1. ECN 661030

## ENGINEERING CHANGE NOTICE

HNF-SD-WM-BIO-002, Rev. 0  
 HNF-SD-WM-IOSR-001, Rev. 0

This update to the WESF Basis for Interim Operation (BIO) and Interim Operational Safety Requirements (IOSRs) satisfies the annual update requirement in HNF-PRO-700. This update includes incorporation of the analyzes and controls in the WIXM Safety Analysis Document (HNF-2316), deletion of two Administrative Controls (AC 5.11 and 5.13), and development of LCO 3.2.

Figure 2-8. Pool Cell Circulation and Drain Lines.

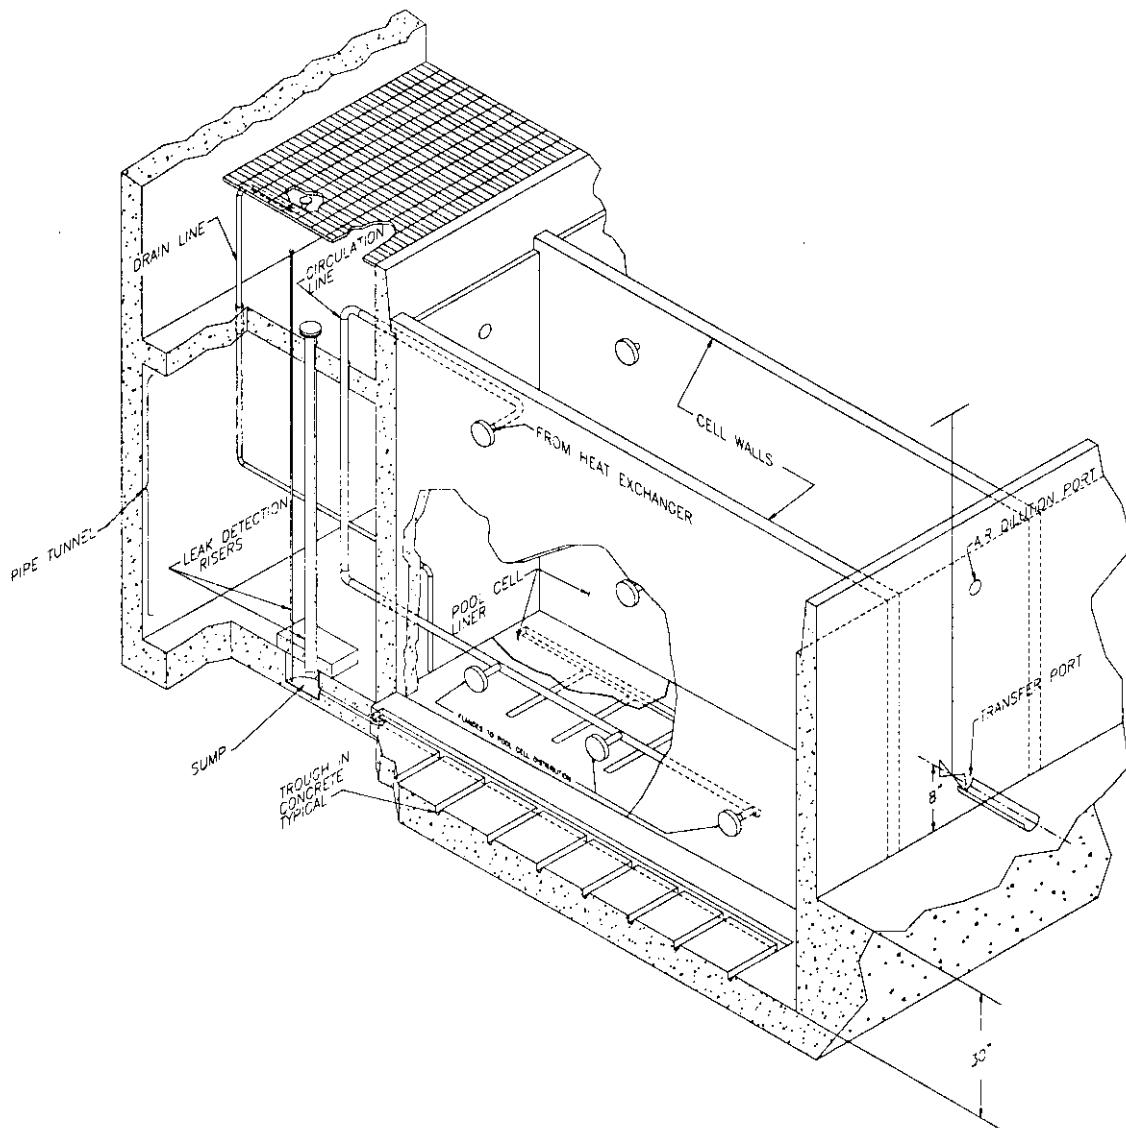
<p>Additional information on the pool cells (such as what each pool cell is used for) is contained in section 2.5.3.1</p>			
			<p>The tunnel will be labeled on Figure 2-8. Period will be added.</p>			
PJM 16	Page 2-19, Section 2.4.10.1 – Show the tunnel on Figure 2-4. Are there any words missing at the end of the last line on this page? Add the missing period.			<p>Sentence will be changed to: "Pool Cells 9 and 10 store collected waste water (e.g., steam condensate) from the Pool Cell Area for sampling prior to batch discharge to the Treated Effluent Disposal Facility (TEDF). Pool Cell 11 (normally dry) contains the pool cell water quality ion exchange system."</p>		
PJM 17	Page 2-22, Section 2.5.3.1, Last paragraph – What is the "collected waste water" stored in cells 9 and 10? Why is it being "stored"?			<p>Each is referring to active pool cells 1 and 3 through 7 and it does circulate continuously. Sentence will be revised to: "To remove the heat generated by the capsules, Pool Cells 1 and 3 through 7 are each provided with a..."</p>

**Figure 3-4. Capsule Storage Pool Water Level Versus Evaporation Time**  
(Single Pool with 149 kW, Six Pools with 403 kW, Eight Pools with 403 kW)

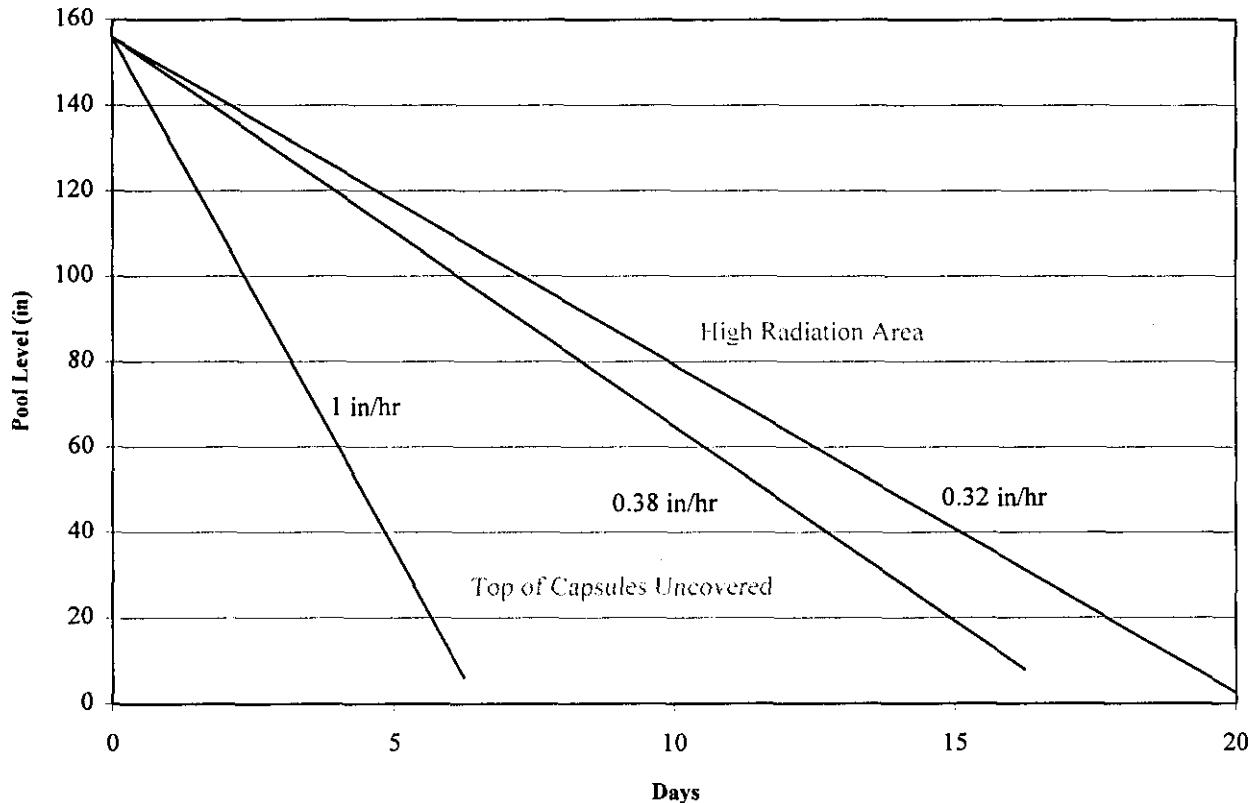
MTC 14	What is the source document for Figure 3-4? Is the data presented elsewhere in the BIO?		<p>There has been no change in the thermal analyses for the capsules. The details of the thermal analyses can be found in SD-WM-TI-770 (pool cells) and SD-WM-TI-771 (F Cell). References to these analyses are located in Table 3-3 as well as in the text section of 3.4.2.4.2 (storage of capsules in F Cell) and 3.4.2.7.1/ 3.4.2.7.2 (loss of water from a single pool and from all pools). [Note: The reference for the thermal analyses is WHC 1996b and WHC 1996c.]</p> <p>The data for this figure is the evaporation rate of 1 in/hr and 0.24 in/hr plotted over several days. Text will be revised in Section 3.4.2.7.2.1 page 3-146 as follows to clarify the basis for this figure:</p>	<p><u>Failure to Add Makeup Water.</u> The WESF operating experience indicates <math>&lt;1</math> to 6 in. per week evaporative losses from a pool cell are normal, depending on ambient conditions that control raw water temperature on the tube side of the heat exchanger. Should pool cooling be lost, the bulk boiling temperature could be reached in no less than 12 hours. The rate of level drop at this point would be a maximum of 2.5 cm/h (1 in/h) or 4 L/min (1 gal/min). This is illustrated in Figure 3-4. These estimates are based on an initial pool temperature of 50 °C (122 °F), a pool level of 138 in. and a thermal pool heat generation of 149 kW, and neglects conduction to the ground or adjacent pools. The basis and conservatism of the 149 kW is discussed in Section 3.4.2.7.1.2.</p> <p>Further down the page.....</p> <p>In addition, the pool cells provide a source of water that is qualified for seismic loads up to the 0.25g DBE. If makeup</p>
